Technical Note

Project:	P18-669 Glan Llyn, Newport
Subject:	Residential Discharge Permit – Schedule 5 Response Technical Note
Date:	February 2026
Document Reference:	18669-RLL-26-XX-RP-O-0852-P01
Prepared by	Chris Wilson – Principal Geo-Environmental Consultant
Checked & Approved by	Howel Morris – Director

Rodgers Leask Ltd (RLL) have been commissioned by Glan Llyn Estate Management Limited to prepare this Technical Note to provide further information in response to a Schedule 5 Notice from the Natural Resources Wales Permitting Team (NRW) to support the Permit Application referenced PAN-029406 for the discharge of surface waters from Glan Llyn, Newport into Monks Ditch via the on-site reën network.

D2-S Ammoniacal Nitrogen & Total Daily Precipitation

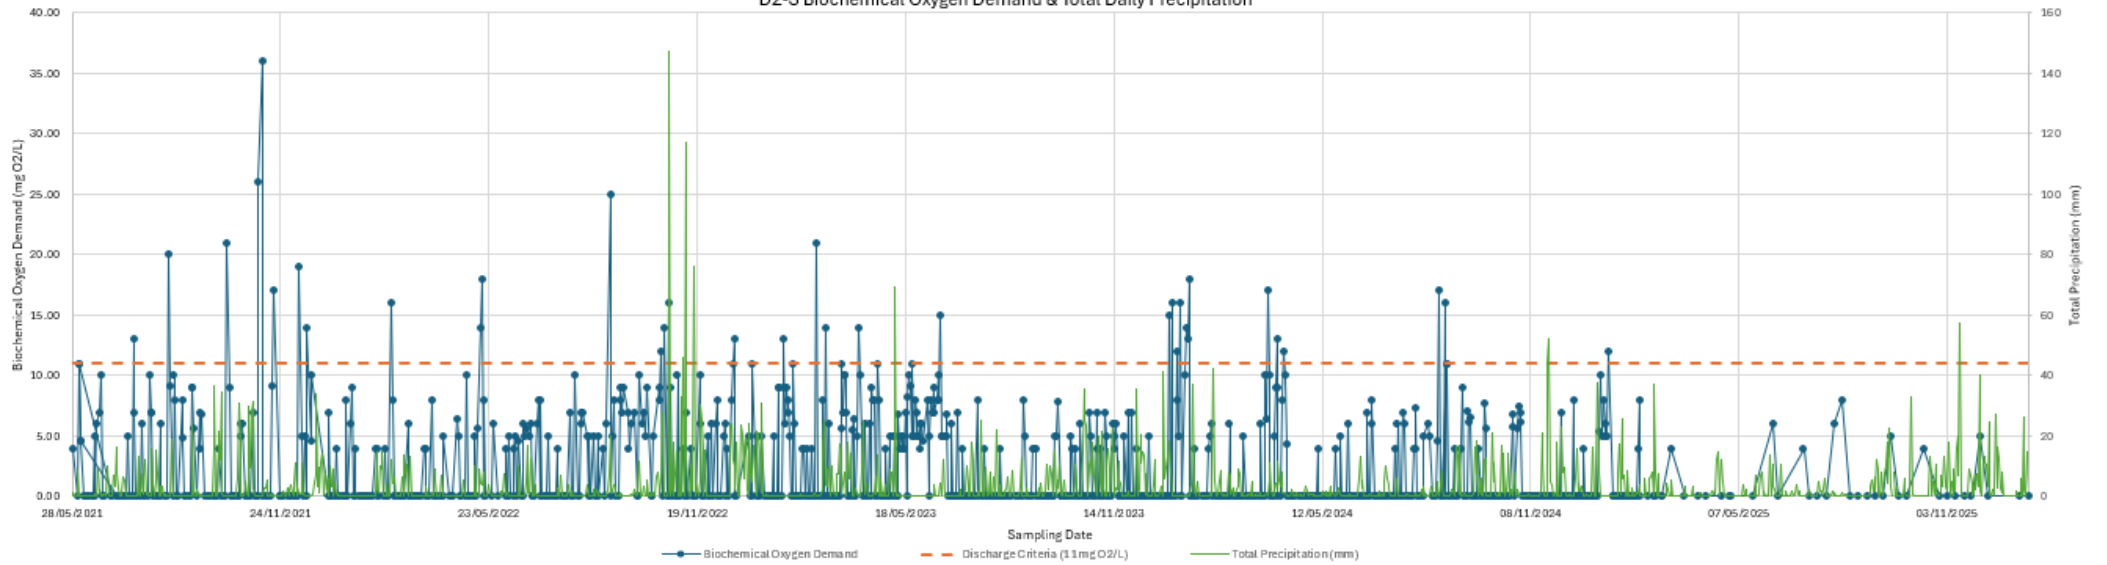
Ammoniacal nitrogen (ammonia) was highlighted in the Section 5 Notice as a determinant of concern where a discharge concentration maximum of 0.8mg/l would apply. Based on the data provided in Figure 1 for the past 3.5 years, surface water within the Glan Llyn reen network occasionally exceeds the 0.8mg/l concentration, although waters appear to have improved over time.

Construction works do not provide a reason for all exceedances of the proposed criteria and for this reason rainfall has been added to Figure 2. Figure 2 shows a trend of elevated ammoniacal nitrogen following prolonged periods of rainfall which may be a result of increased surface run off from exposed Made Ground on the undeveloped part of the site or influent from off site. It is thought that as the site is built out and interception increases the amount of surface run-off will reduce and likely lead to a reduction in ammoniacal nitrogen entering the reen network. To mitigate intermittent exceedances of the ammonium discharge criteria the implementation of a telemetrically controlled part-time ammoniacal nitrogen treatment system for the water in the reen is proposed.

Seasonal change is also shown on Figure 1 to impact the ammoniacal nitrogen levels within the reen network. Ammoniacal nitrogen is an important source of nitrogen for plants and during the growing season (spring/ summer) and a reduction in concentration is evident in the reen, reeds also act as a natural filter for the waters when mature. In winter we have the converse of this where plants die back and decay, releasing ammoniacal nitrogen back into the watercourse whilst also not growing and therefore not taking up nitrogen. It is for this reason that an annual vegetation management strategy is proposed.

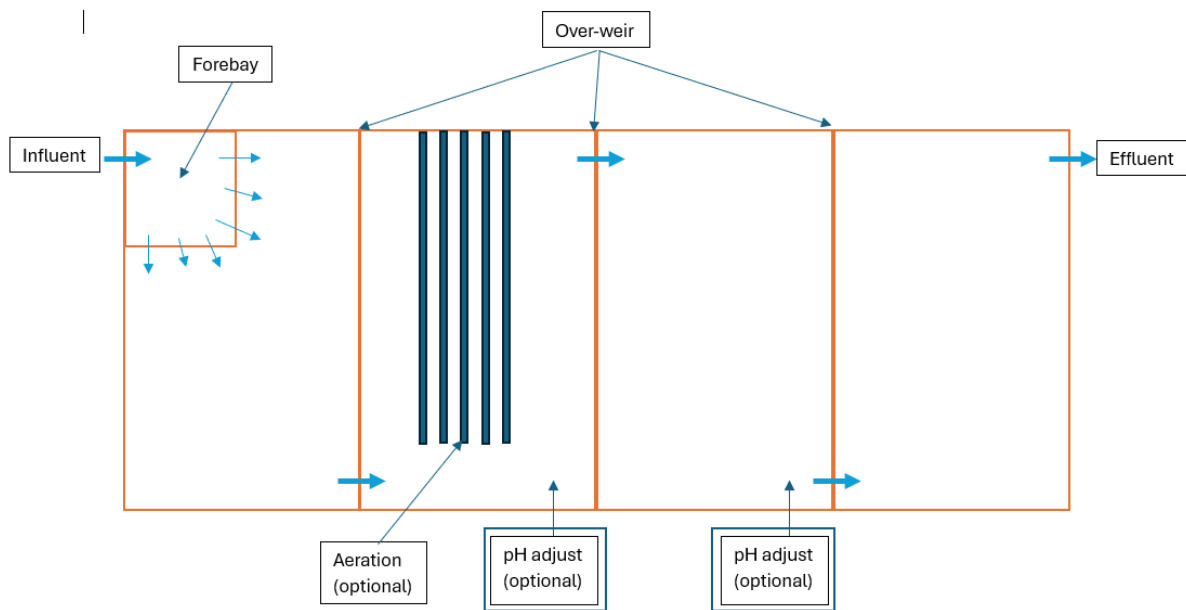
1. Provide a revised management plan/operating technique that details how treatment of the discharge will be achieved. This should include (but not limited to)
 - a. a map showing the location of the treatment system, type of treatment to be used, ongoing maintenance of the treatment system, contingency plan for failure (if applicable) and long term expectation of the system and the discharge quality.
 - b. The limits that are required to be achieved in the discharge are:
Ammonia 0.8 mg/l as a maximum
and
BOD 11 mg/l as a maximum
 - c. Details of the ongoing sampling regime to be used to monitor the following chemicals identified as requiring further monitoring after assessment:
Sulphate
Chromium
Chloride
Copper
Manganese
Nickel

To further improve the ammoniacal removal in the example settlement lagoon, it can be retrofitted with the potential to add a flocculant/ coagulant polymer at the inlet stream via an in-line mixer. The use of a flocculant/ coagulant polymer will aid colloidal solids capture and precipitate metals which were outlined in the Section 5 notice. To ensure that an environmentally friendly polymer is used, an aquatics specialist has been consulted who are a provider of a gel polymer which is environmentally friendly and non-accumulative in aquatic species.

The settlement lagoon could also be retrofitted to remove ammoniacal nitrogen as a gas (ammonia) through aeration and pH adjustment. pH adjustment shall be controlled through the use of sustainably sourced sodium hydroxide (caustic soda) and an acid (likely hydrochloric acid) if required depending on pH criteria for discharge.
